Proposal for amendments to ECE/TRANS/WP.29/GRE-68-04

(Proposal for amendment to Regulation No. 48)

Theoretical chemical behaviour of halogen light sources

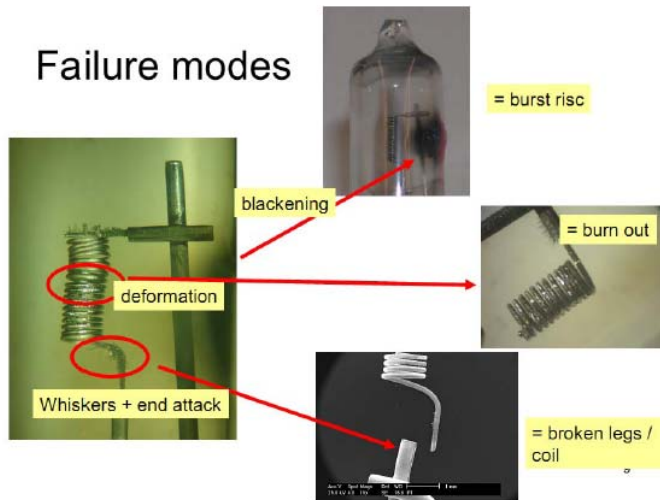
- Paragraph 5.9.2: GRE-68-04 limits the possibilities of changing the luminous intensity of the principal passing beam. That may be in contradiction to the different passing beam modes allowed by Regulation 123.
Moreover, it would not allow the Tourist Mode, already largely available on the market.
- Paragraph 5.27.4 proposes an answer to the concerns raised by IEC in document GRE-67-30, pages 6 and 7 (reproduced here below for reference purposes)

The theoretical behaviour referred to in the above pictures does not justify the complex changes proposed in GRE-68-04. Before adopting the proposal, it would be important to get empirical data on such behaviour, in order to be able to correctly evaluate the probability of the above failure modes. OICA does not accept the proposed changes since such probability seems very low.
